Staff Report

To: Salt Lake City Planning Commission
From: Linda Mitchell, Principal Planner, linda.mitchell@slcgov.com
Date: May 7, 2020
Re: PLNPCM2019-01079 – *Detached Accessory Dwelling Unit*

Conditional Use

PROPERTY ADDRESS: 1020 S Lincoln Street
PARCEL ID: 16-08-328-015-0000
MASTER PLAN: Central Community – Low Density Residential
ZONING DISTRICT: R-1/5,000 Single-Family Residential

Figure 2. Site Plan

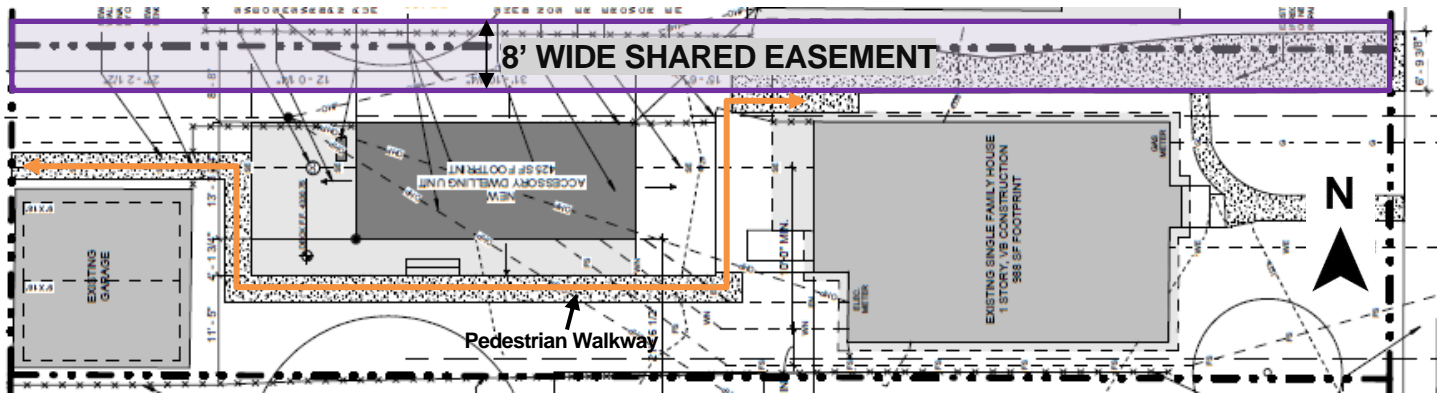
During the early notification process, staff received an email from a neighbor ([Attachment G](#)) expressing concerns about the possible encroachment of the proposed ADU on a shared easement between the subject property and the abutting property to the north. According to the Warranty Deed ([Attachment C](#)) for the subject property, the right-of-way easement is eight-foot (8') wide, with five feet (5') over the subject property and three feet (3') over the abutting property to the north (see *Figure 2*). The proposed ADU is approximately 8'-8" from the abutting property to the north. Therefore, the proposed ADU does not encroach on to the right-of-way easement (i.e., shared easement).

Also, the drawings show the ADU location extending beyond (north of) the easement line and current fence line. Because this ADU sits along our side yard, it is very visible from our home, and a large bank of kitchen windows)--the closest point to the ADU and most frequently used space in our house. I did review the zoning on how the ADU needs to be placed as a setback from a ROW or alley. I did not see how an easement is considered in the zoning, so I am not clear what is required in a case like this. It would help for the setback requirement to be used on the easement, as if it were the property line, and for the ADU to be behind the current fence line.

Show and identify the right-of-way easement as described in the Warranty Deed No. 11066480 (BK 9875 PG 967).
